# TX3 New -256 Products

This document describes the differences between current TX3 products and the new products ending in **-256**. For any information not covered in this document, see the appropriate TX3 manual.

**Figure 2. TX3 devices on an Ethernet network - new configuration**

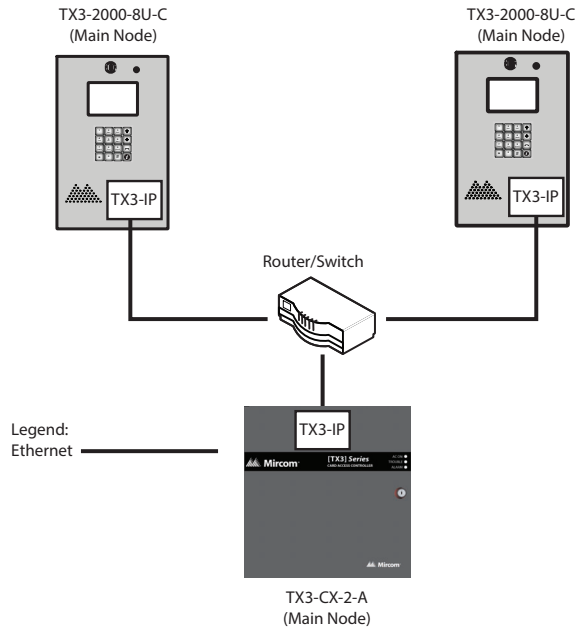
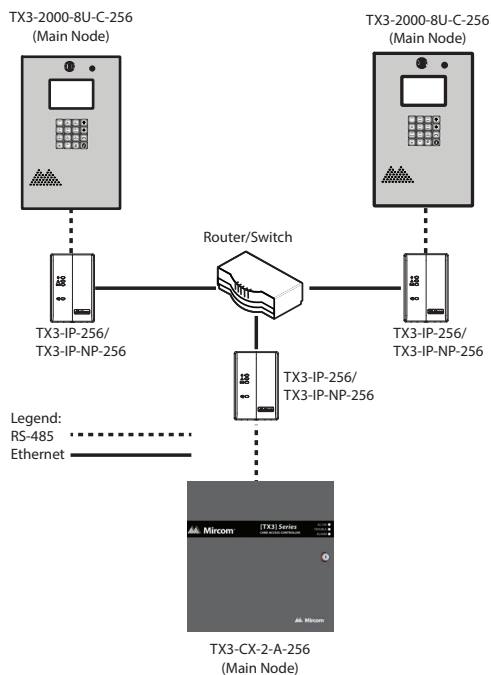
Figure 1 shows the old method for networking TX3 devices in an Ethernet network. Each device has an internal TX3-IP module that connects to the Ethernet network.

Figure 2 shows the new method. The TX3-IP module is no longer used. Each device that is connected to Ethernet must have a TX3-IP-256 or TX3-IP-NP-256 IP adapter module connected to it by RS-485. The IP adapter module is a bridge between RS-485 on the device side, and Ethernet on the network side.

**Figure 4. TX3 devices on a mixed network - new configuration**

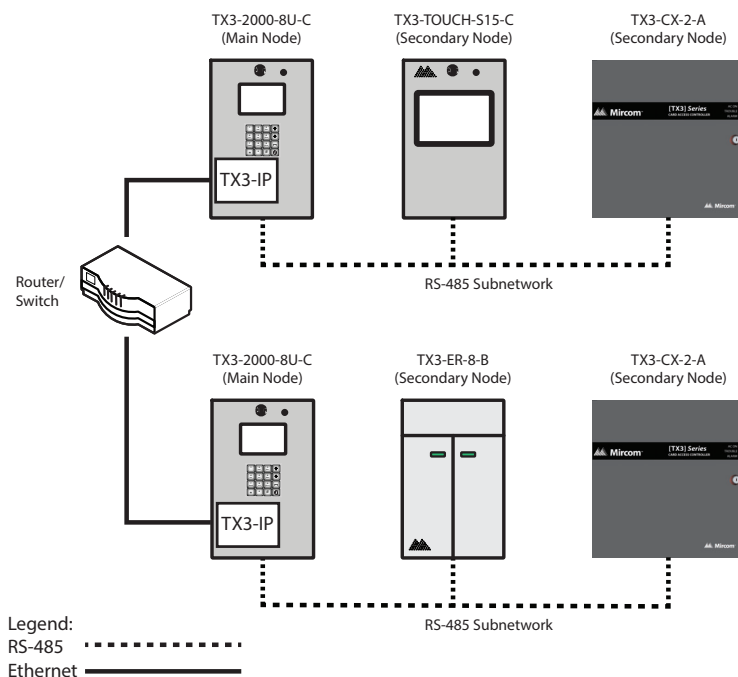
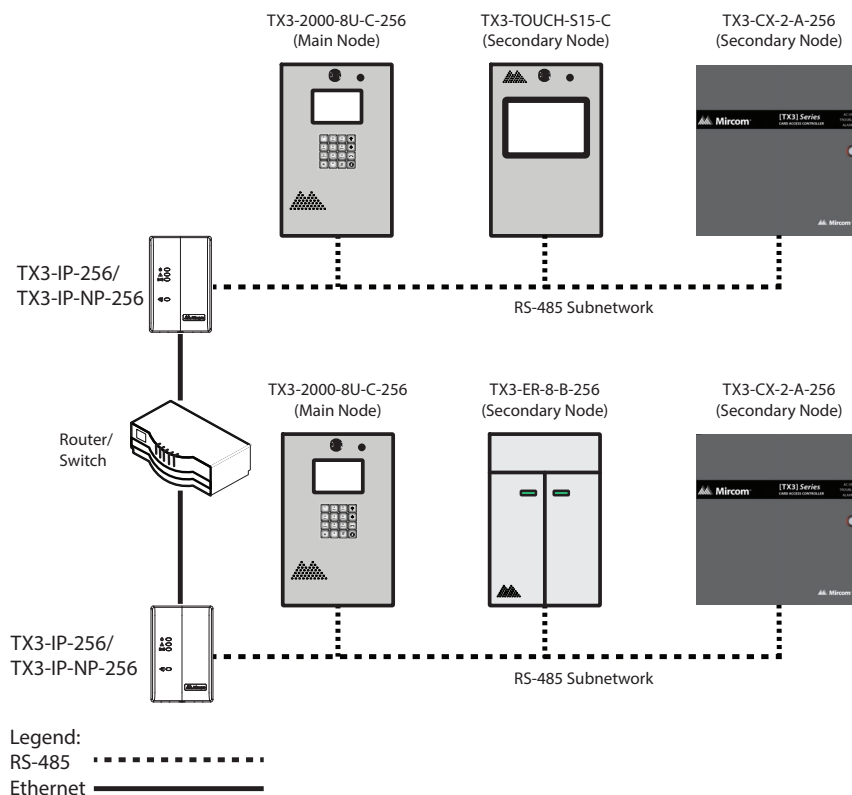
Figure 3 shows the old method for networking TX3 devices in a mixed RS-485 and Ethernet network. Each device connected to Ethernet has an internal TX3-IP module installed.

Figure 4 shows the new method for networking on a mixed network. The TX3-IP module is no longer used. The IP adapter module is a bridge between RS-485 on the device side, and Ethernet on the network side.

**Figure 5. Old and new devices on a mixed network**

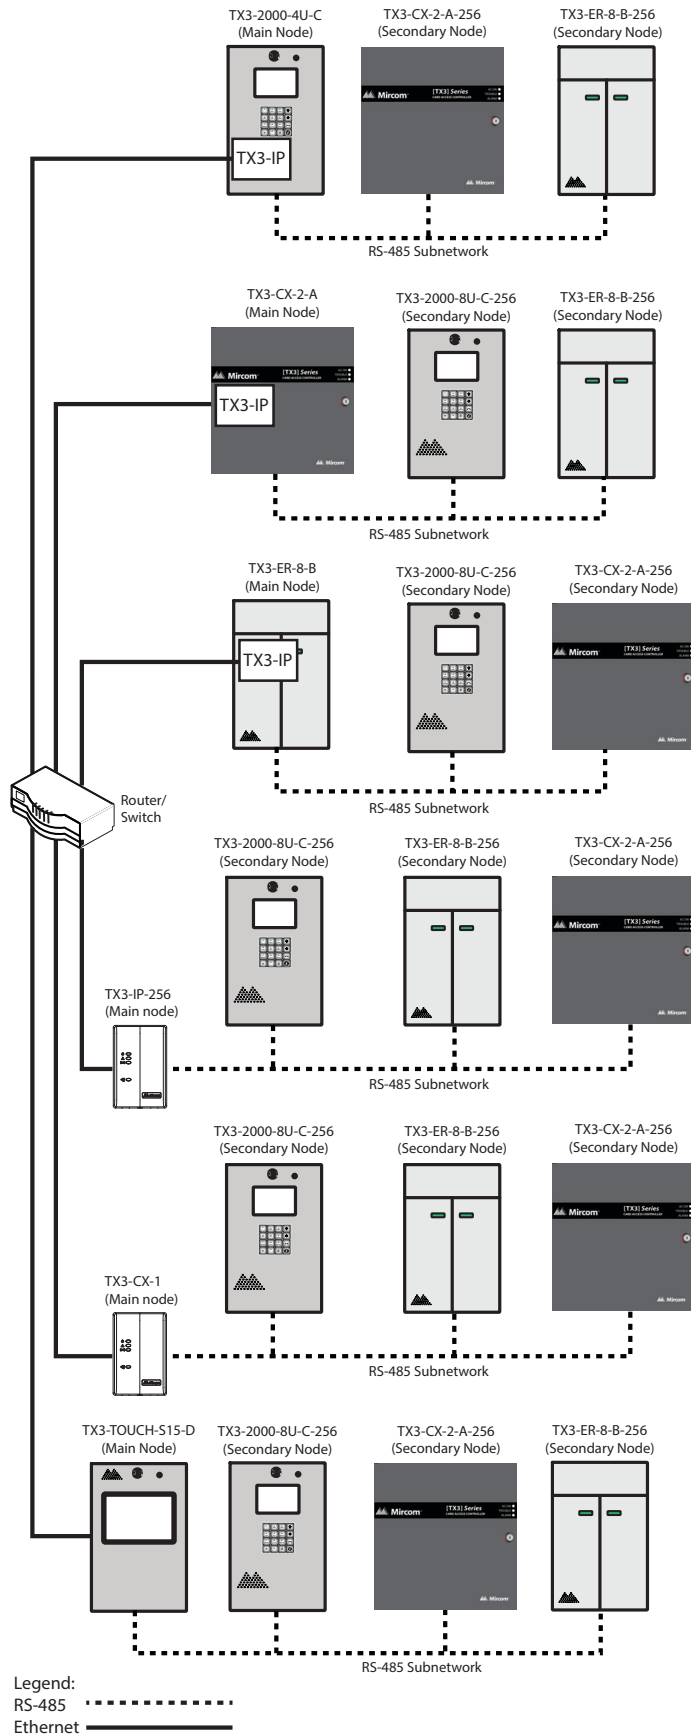
Figure 5 shows a mixed network with both old and new (-256) models. Old and new models can be on the same RS-485 network.

Figure 6. TX3-IP-256 and TX3-IP-NP-256

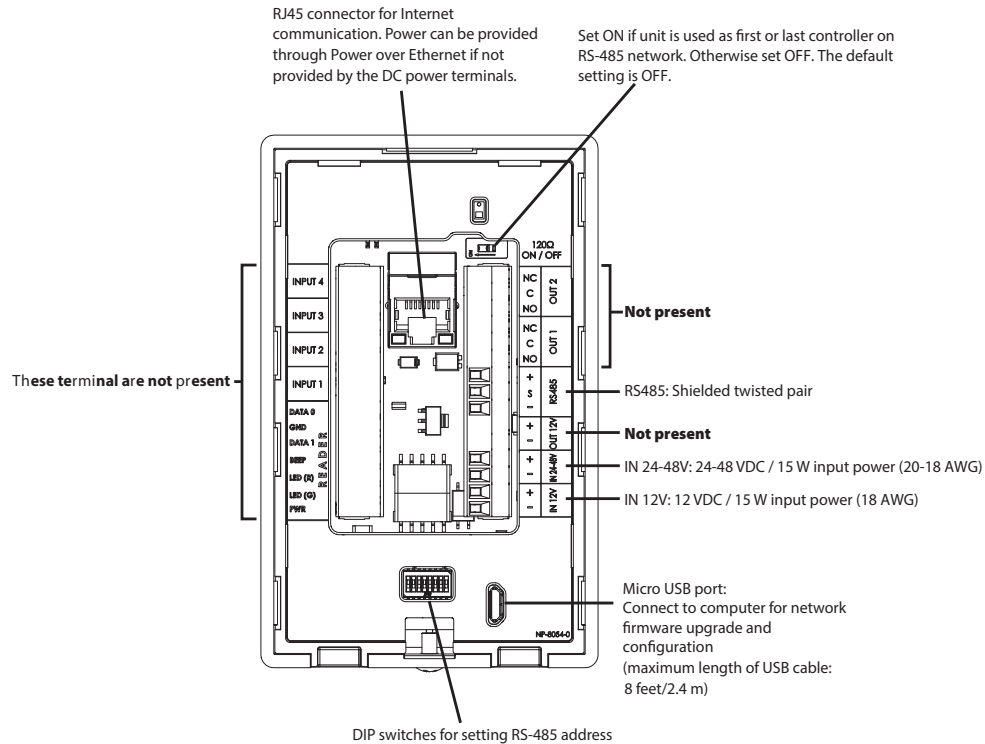
The TX3-IP-256 and TX3-IP-NP-256 serve as IP adapters for models ending in **-256**. They resemble the TX3-CX-1 and TX3-CX-1-NP single door controllers, but they have no door controller functionality. They are powered the same as TX3-CX-1 and TX3-CX-1-NP. Their mechanical installation is the same as TX3-CX-1 and TX3-CX-1-NP. See the documents LT-2085-256 and LT-5997-256.

**Figure 7. Add TX3-IP-256 or TX3-IP-NP-256 in the TX3 Configurator**

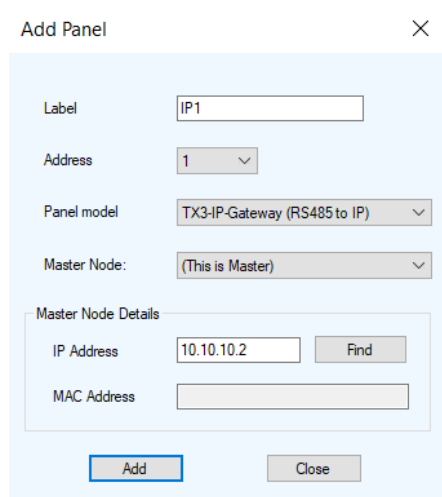
The exceptions are TX3-IP-256 and TX3-IP-NP-256, which are named **TX3-IP-Gateway (RS485 to IP)**.

The TX3-IP-256 and TX3-IP-NP-256 serve as Mains (Masters) for the other -256 models.
